UNITED STATES PATENT AND TRADEMARK OFFICE

APPLICATION NO.	FILING DATE	FIRST NAMED INVENTOR	ATTORNEY DOCKET NO.	CONFIRMATION NO.
10/051,433	01/18/2002	Geoffrey Hamilton White	PAT-1285DIV	5904

Office Action Summary

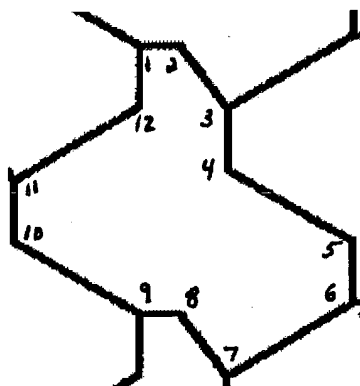
Claims 23-26, 29, 33, 34, 36, 37, 40, 44, 45, 47-49, 52, 56, 57, 59, 60, 63, 67 are rejected under 35 U.S.C. 102(e) as being anticipated by Jang (5922021). Fig. 3B shows a stent cell that has exactly 12 bends and exactly 4 struts connected with each other to form the cell. It can also be seen the struts have exactly two spaced apart bends. It can also be seen that bend # 8 is "centrally located" and extends into the cell and at least 4 bends extend outside the cell. Also shown below, 1st and 2nd rows differ in orientation.

example of a cell

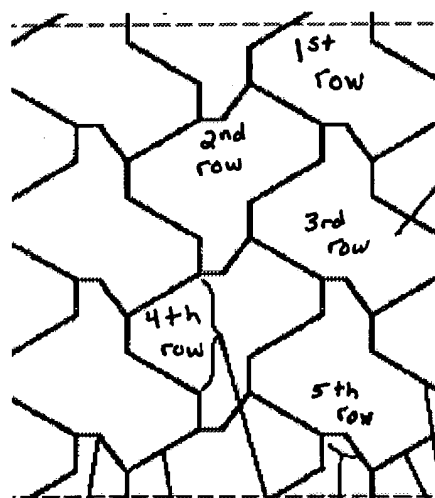
shows adjacent cells and rows
